SERVICE BULLETIN MAINTENANCE OF WAY EQUIPMENT

DATE: 6-3-2005 **BULLETIN NO:** 05-007

TITLE: 4008715 SQUEEZE-IN RELIEF KIT

PRODUCT SERIES / MODEL: MARK IV Tampers

FIGURE 1
MACHINES WITH JUPITER - 2002 AND LATER

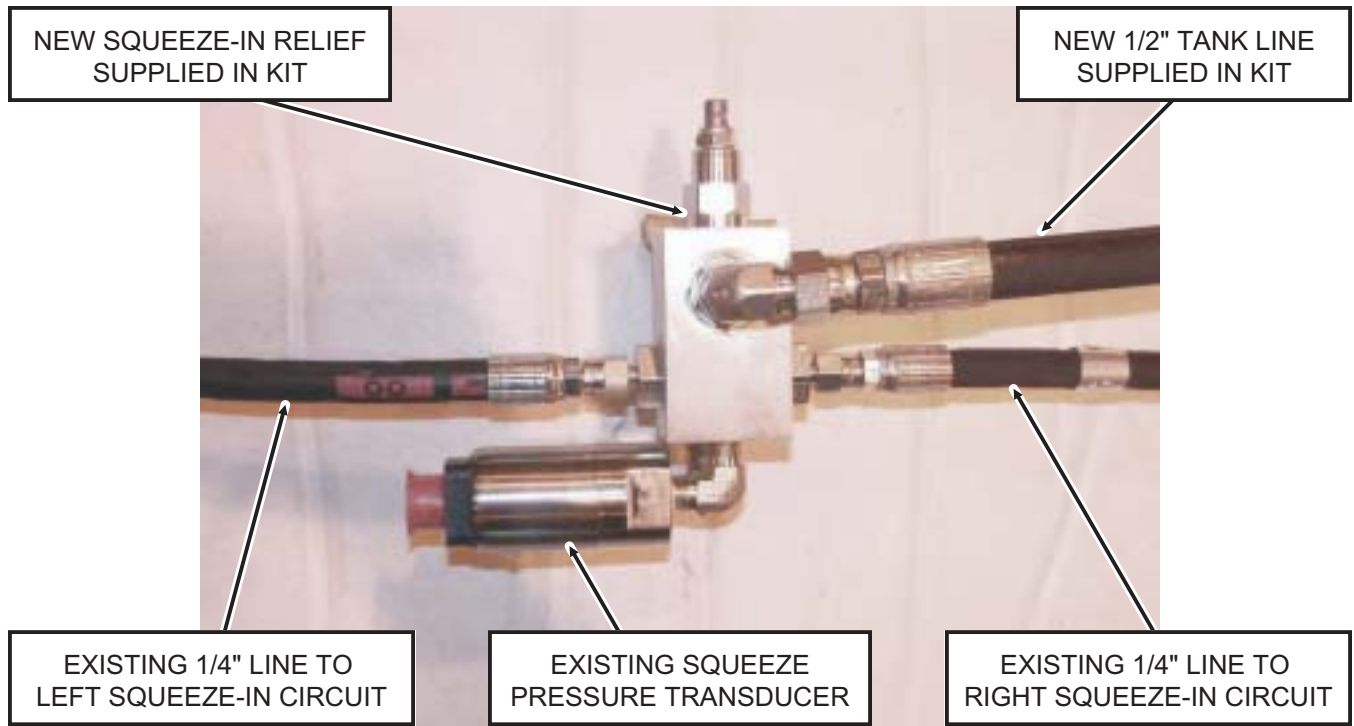
6. When disconnecting hydraulic lines and fittings, be sure to catch all hydraulic fluid in a leak-proof container.
7. **Machines With Jupiter:** Locate the existing tee that the squeeze pressure transducer is connected to on the Upper Traverse Beam. Then follow the instructions on Drawing #4008715 and Figure 1 to install the Squeeze Relief Kit components.

FIGURE 2
MACHINES WITHOUT JUPITER - 2001 AND BEFORE

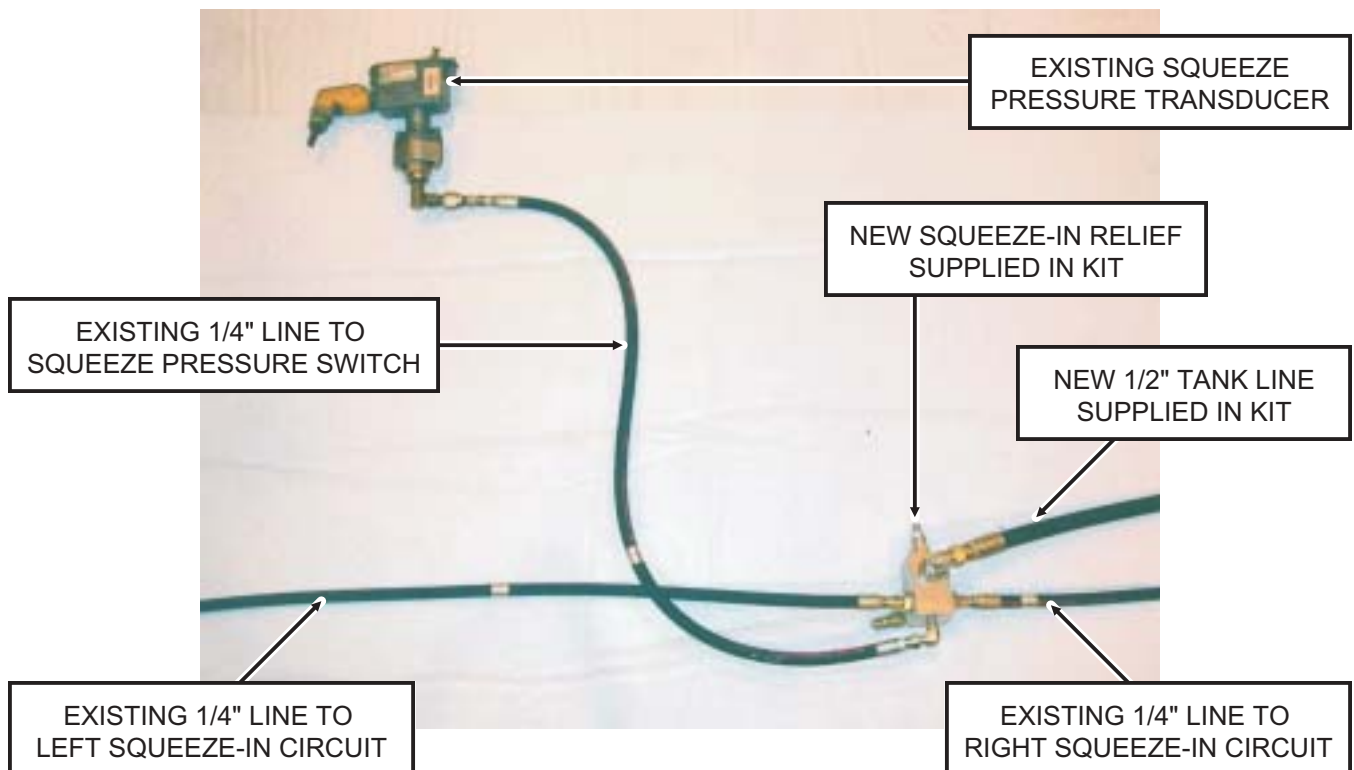
8. **Machines Without Jupiter:** Locate the existing tee that the squeeze pressure switch is connected to on the Upper Traverse Beam. Then follow the instructions on Drawing #4008715 and Figure 2 to install the Squeeze Relief Kit components.

SQUEEZE-IN RELIEF KIT	
Drawing Number	4008715
Machine Type	METRA MK IV
Drawn	PJG
Checked	JOC
Scale	1:4

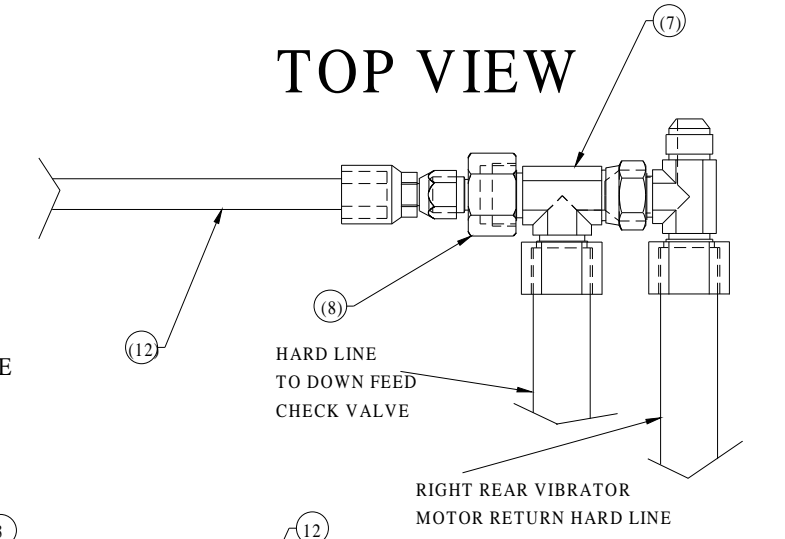
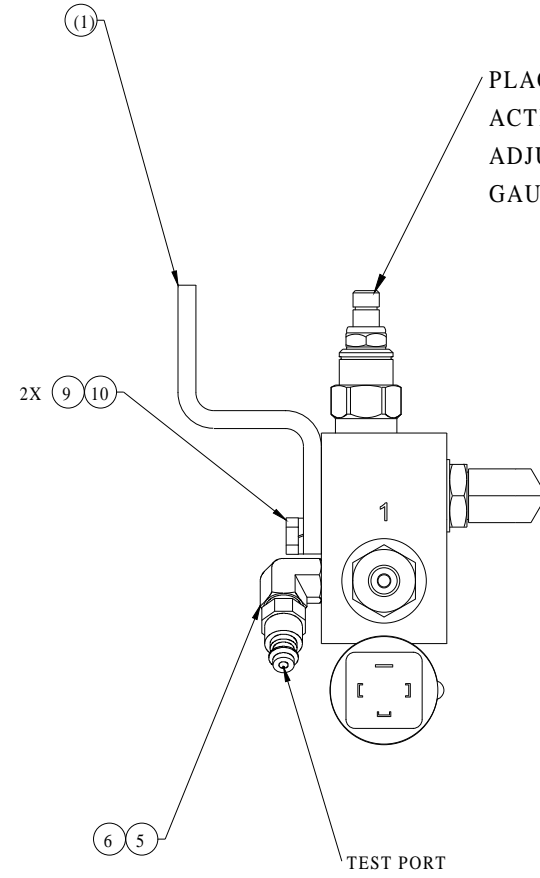
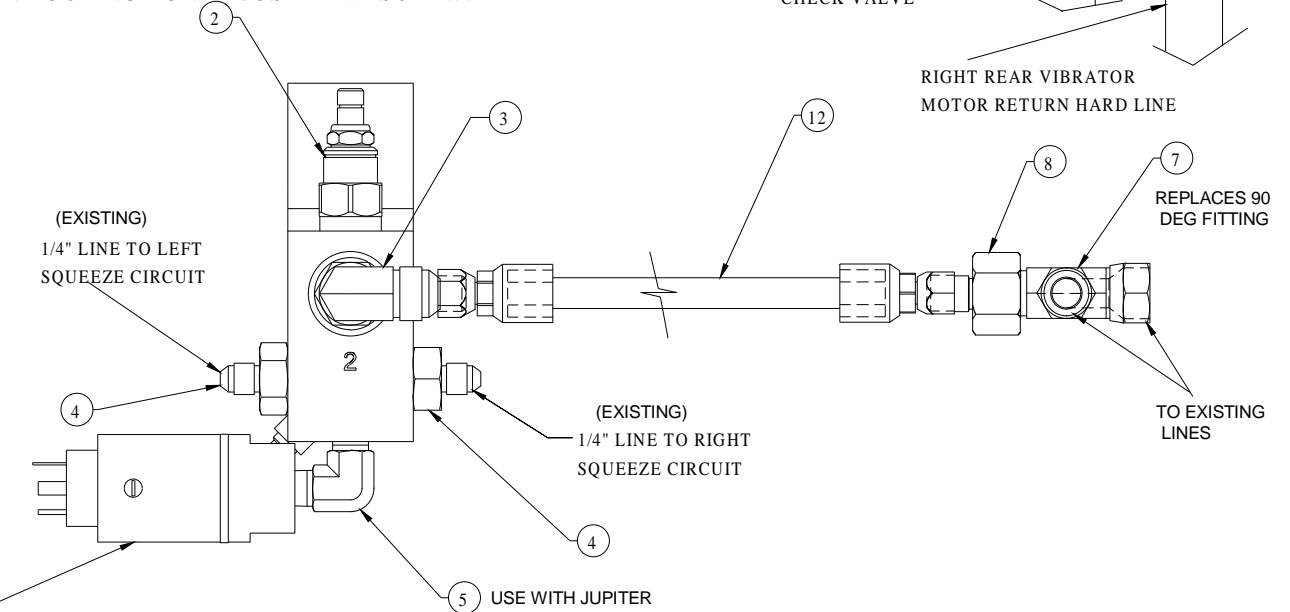
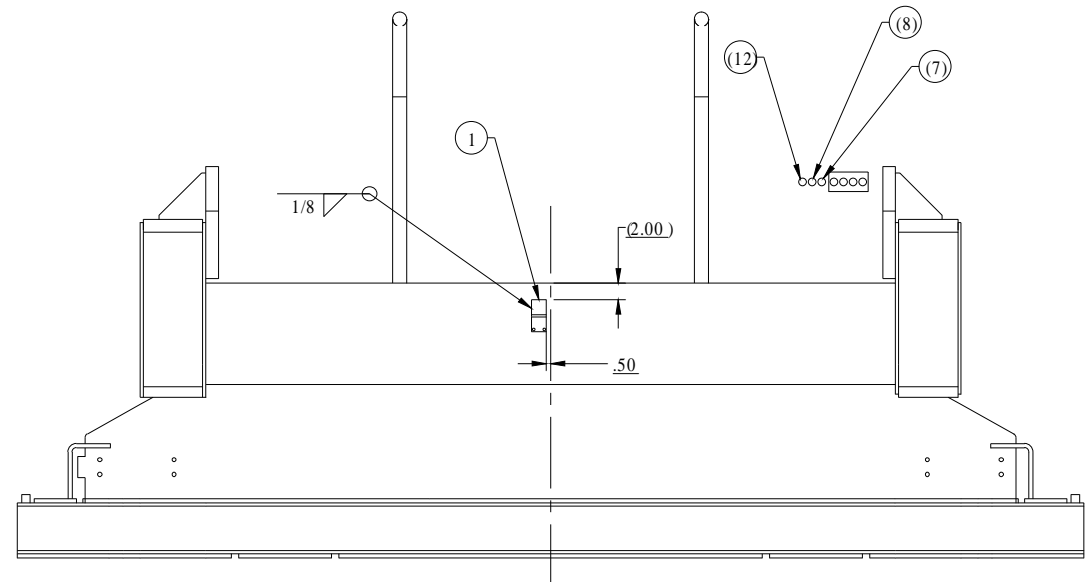
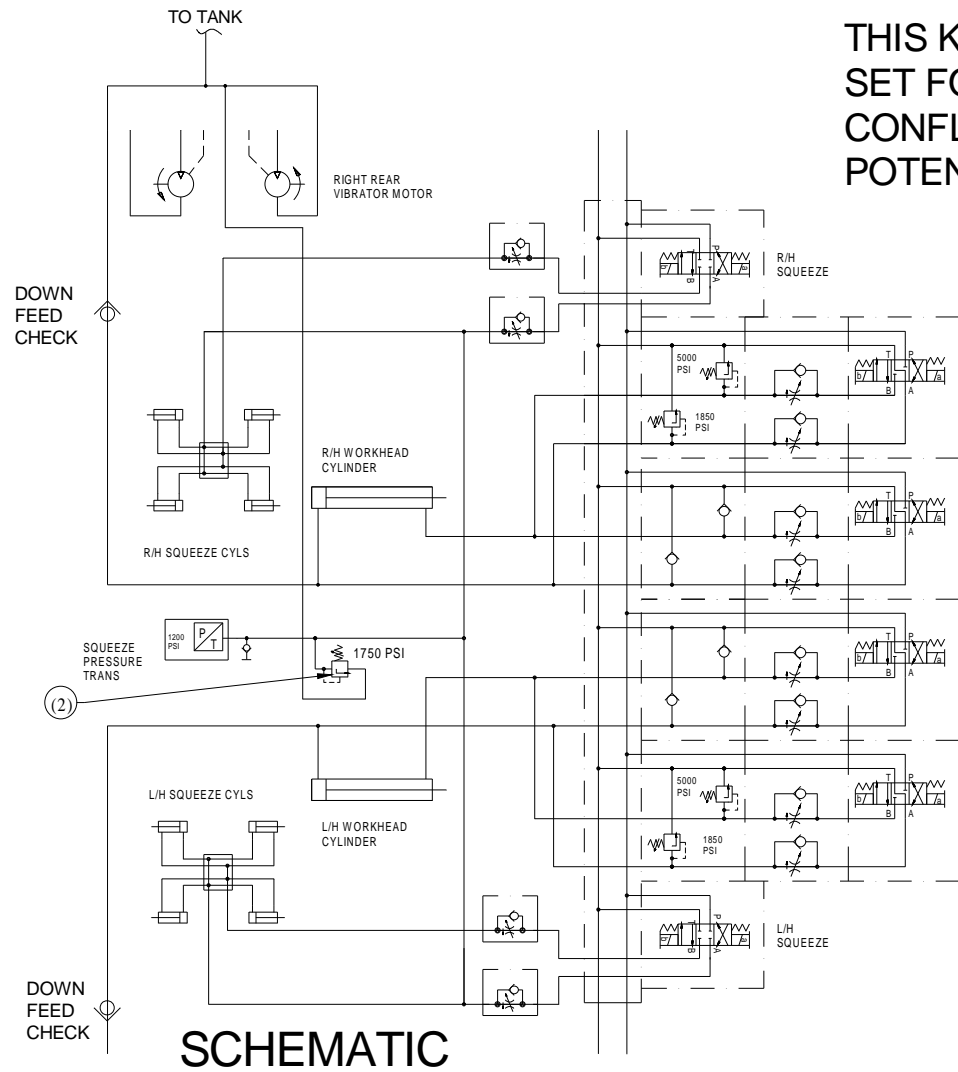
THIS KIT PROVIDES A RELIEF VALVE IN THE SQUEEZE-IN CIRCUIT THAT IS SET FOR 1750 P.S.I. THIS IS HIGH ENOUGH THAT IT DOES NOT CAUSE A CONFLICT WITH THE SQUEEZE PRESSURE SETTING, BUT WILL RELIEVE POTENTIALLY DAMAGING PRESSURE SPIKES.

PLACE GAUGE ON TEST PORT, ITEM 6, START MACHINE, ACTIVATE "SQUEEZE-IN" FOR EITHER WORKHEAD AND ADJUST THE RELIEF VALVE UNTIL 1750 PSI SHOWS ON THE GAUGE. TIGHTEN LOCK NUT ON ADJUSTMENT SCREW.

ON JUPITER MACHINES, INSTALL EXISTING SQUEEZE PRESSURE TRANSDUCER AS SHOWN. FOR NON-JUPITER MACHINES, RECONNECT HOSE GOING TO SQUEEZE PRESSURE SWITCH INCLUDING ANY RESTRICTOR FITTINGS THAT WERE PRESENT AT THE TEE THAT IS BEING REPLACED BY THE RELIEF VALVE.
